TITLE: Notification that – ISO/IEC 14443-3:2010/FDAM4 - Identification cards - Contactless integrated circuit(s) cards - Proximity cards - Part 3: Initialization and anticollision - AMENDMENT 4: Electromagnetic disturbance handling and single size UID – has been posted to the ISO server for FDAM ballot

ISO/IEC 14443-3:2010/FDAM 4:2010(E)

AMENDMENT 4: Electromagnetic disturbance handling and single size UID

Figure 1 — Frame delay time PCD to PICC

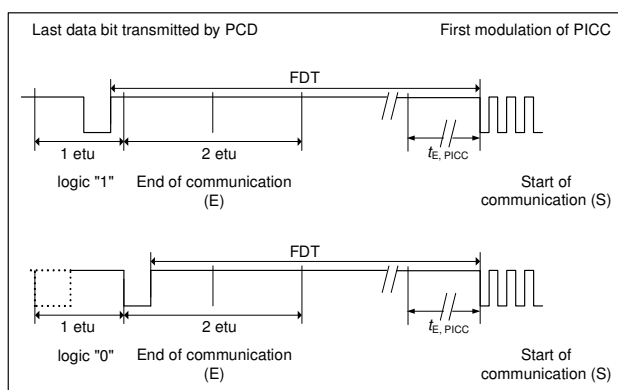
Page 7, 6.2.1.1

Replace Figure 1 with the following figure and add the note after Figure 1:

"NOTE $t_{E,PICC}$ is specified in clause 8."

Figure 17 — Timing before the PICC SOF

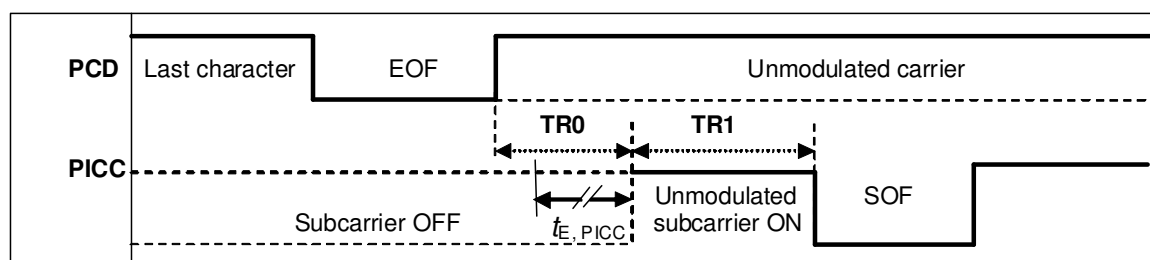
Page 28. 7.1.6

Replace Figure 17 with the following figure and add the note after Figure 17:

"NOTE $t_{E, PICC}$ is specified in clause 8."

Figure 33 — Low EMD time

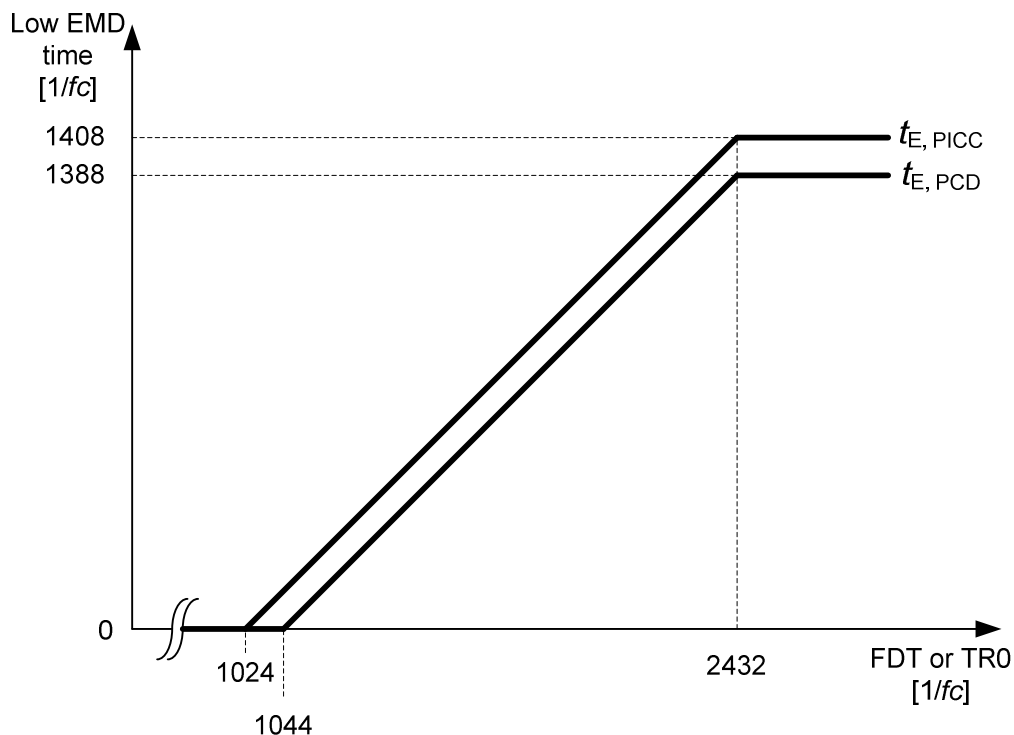
The low EMD time for PCD and PICC are illustrated in Figure 33.

The low EMD time $t_{E,PICC}$ is the time period before the start of PICC data transmission, when the PICC shall not produce an EMD level higher than the EMD limit as defined in ISO/IEC 14443-2/Amd.3.

This low EMD time $t_{E,PICC}$ has a value of $F - 1024/fc$ with a maximum value of $1408/fc$ where F equals FDT for Type A and TR0 for Type B. The value is $0/fc$ for $TR0 \leq 1024/fc$.

The low EMD time $t_{E,PCD}$ is the time period to allow the PCD to recover from electromagnetic disturbances.

The PCD shall be ready to process a PICC frame no later than $t_{E,PCD}$ after the last time the EMD level was above the EMD limit as defined in ISO/IEC 14443-2/Amd.3.

This low EMD time $t_{E,PCD}$ has a value of $F - 1044/fc$ with a maximum value of $1388/fc$ where F equals FDT for Type A and TR0 for Type B. The value is $0/fc$ for $TR0 \leq 1044/fc$.
